MEMORANDUM

RE: Balakirsky Property, Lot 2
11811 Chapel Estates Drive
Clarksville, MD 21029

After review of the BAT plan here are my comments.

BAT SITE PLAN
11011 CHAPEL ESTATES DRIVE
BALAKIRSKY PROPERTY, LOT 2
PLAT #23207
ZONING: RC-DEO
TAX MAP No. 29 GRID No. 14 PARCEL No. 42
FIFTH ELECTION DISTRICT HOWARD COUNTY, MARYLAND
SCALE: AS SHOWN DATE: APRIL 2018
SHEET 1 OF 3

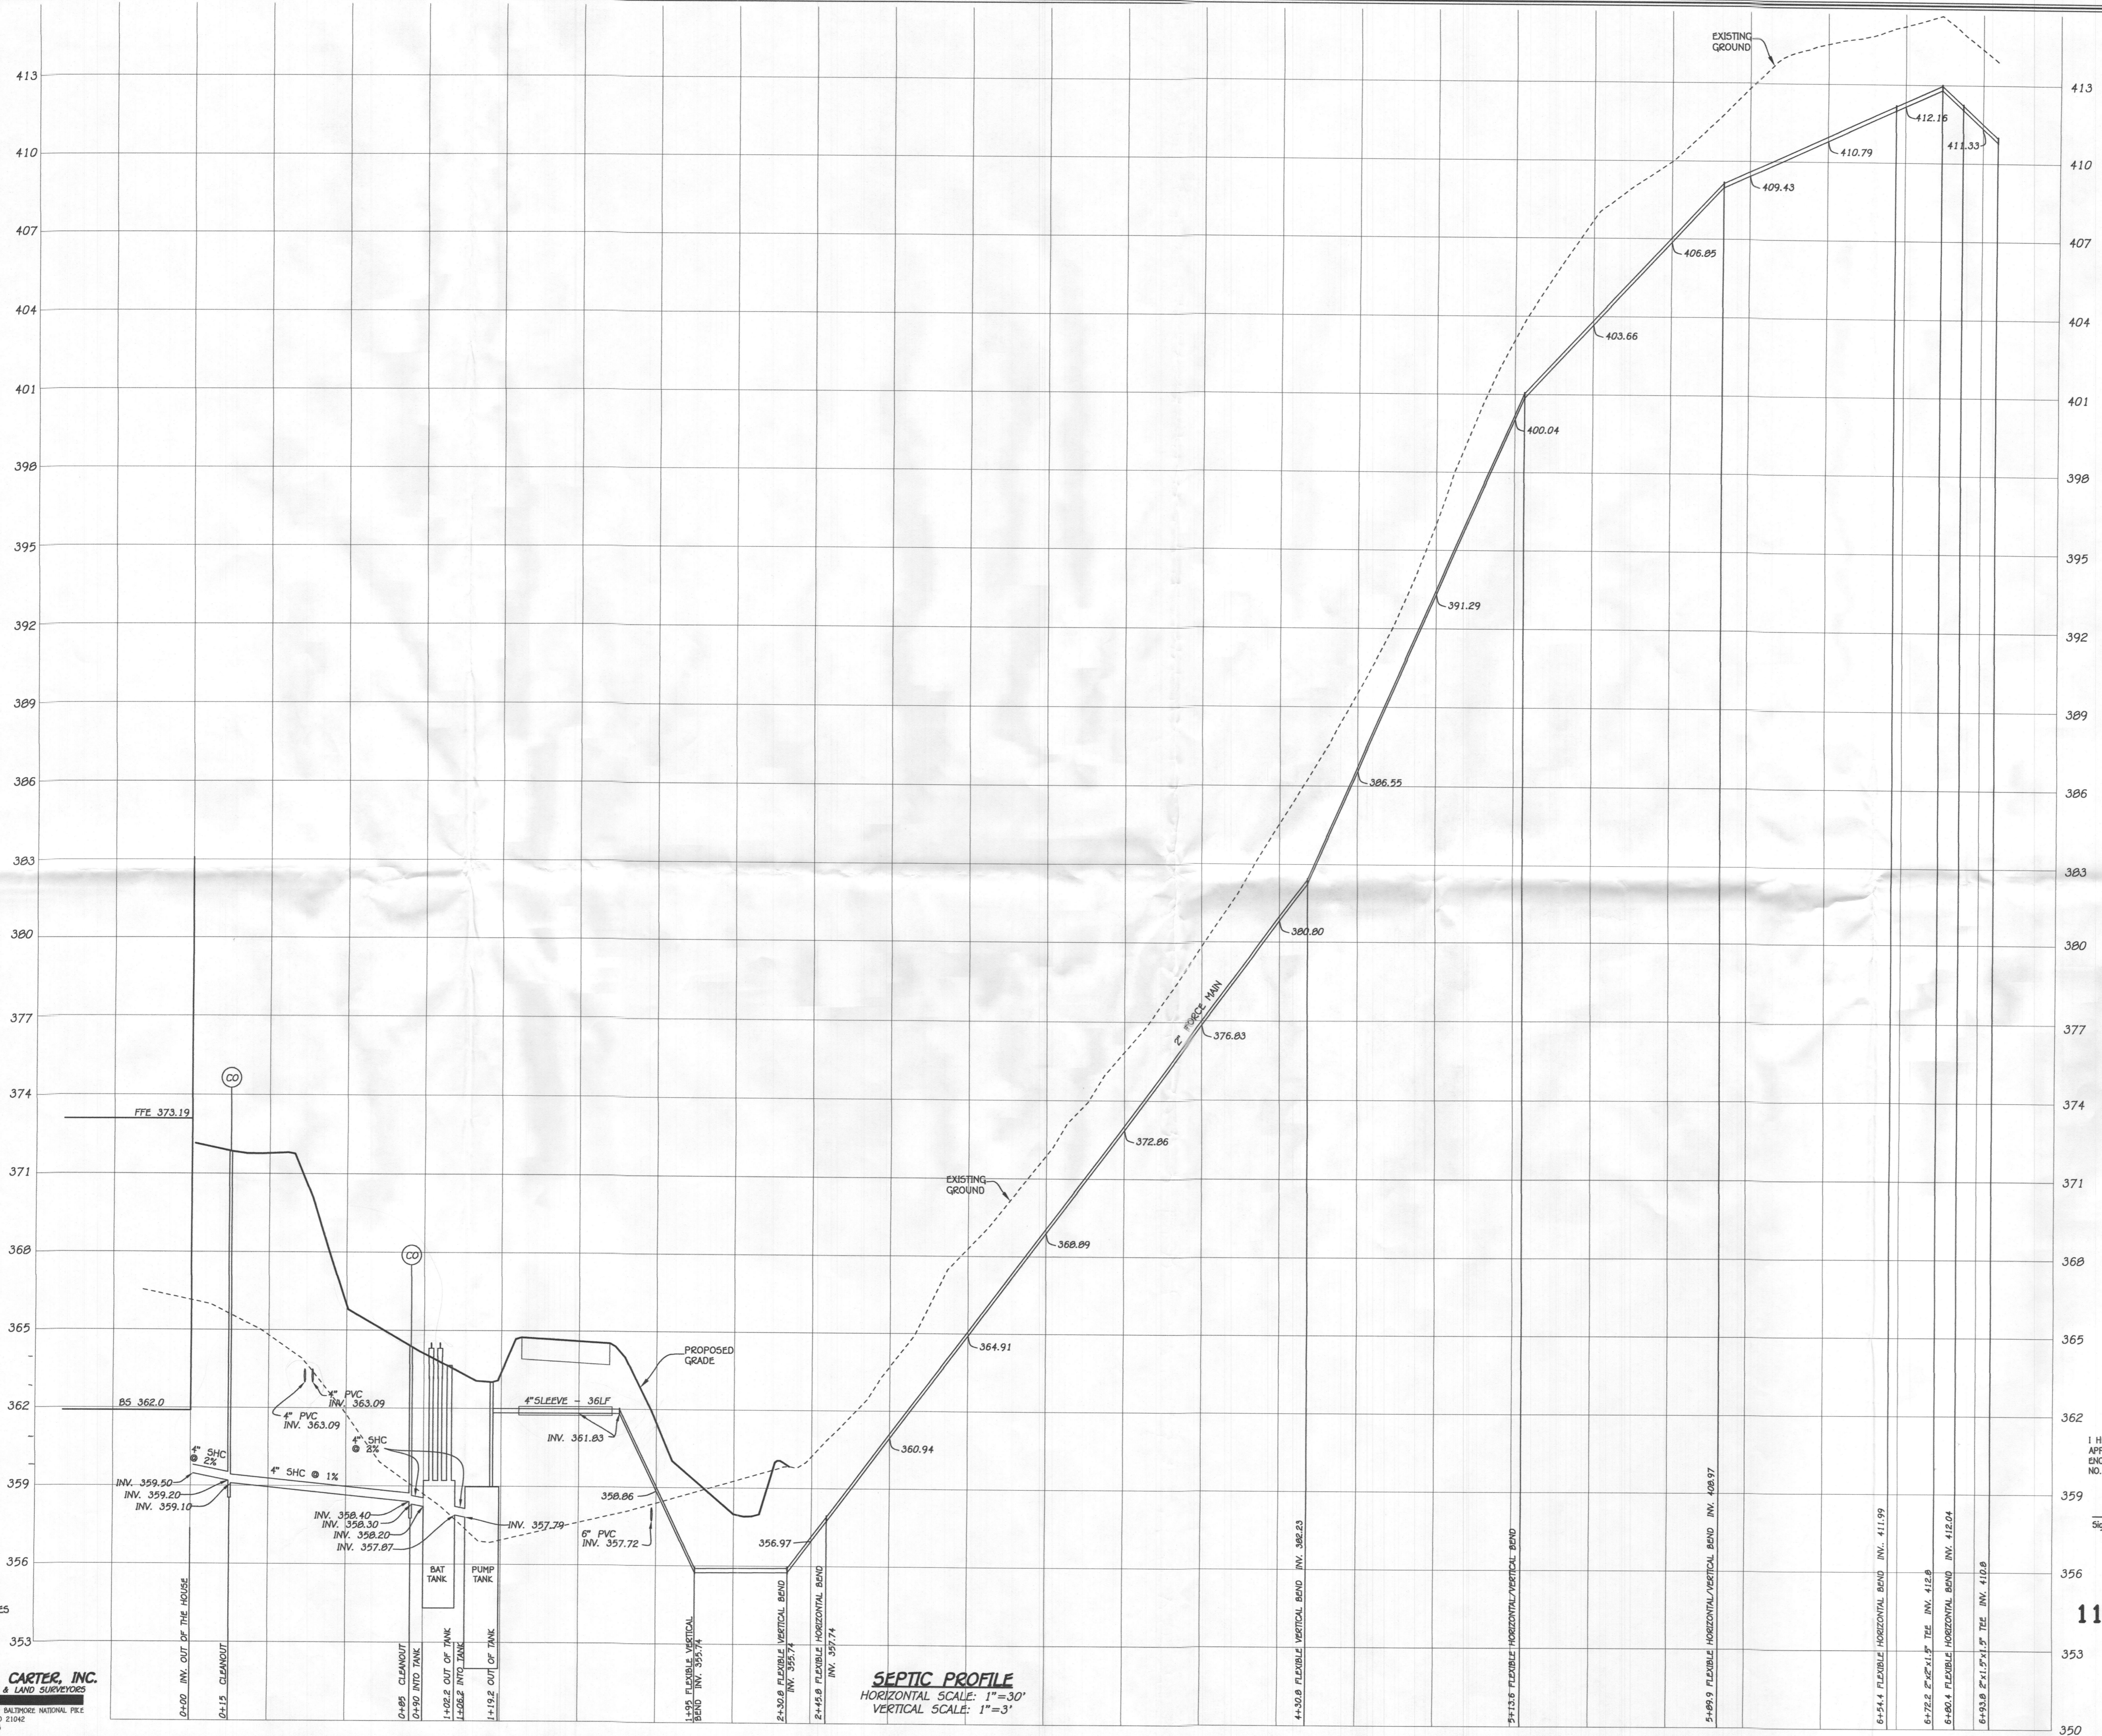
- All elevations listed on the 1st page must correspond with elevations on the 2nd page septic profile. Elevations for the top of the tanks, cover over tanks, and invert out of pump tank do not match up.
- The force main should not be directly feeding into trench 1A. The force main should be entering the manifold between 1A & 1B/C and turning up into 1A and down into 1A/B.

- Septic tanks and pump tanks cannot be within 100ft of a stream.
- The septic tank and pump tank cannot have more than 3ft of cover.
- Add the note: "The blower may not be located more than ____ feet from the tank based on the manufacturer's specifications."

1. Well box has been shown.
2. Tanks have been relocated.
3. Legend has been updated.
4. As discussed, traffic bearing tanks are being used with thicker slabs. Less than 5 foot of cover has been proposed.
5. Sleeve has been added.
6. A 2" pumped line is proposed. Labeling has been made consistent.

- THE BLOWER MAY NOT BE LOCATED MORE THAN 50 FEET FROM THE TANK BASED ON THE MANUFACTURER'S SPECIFICATIONS.
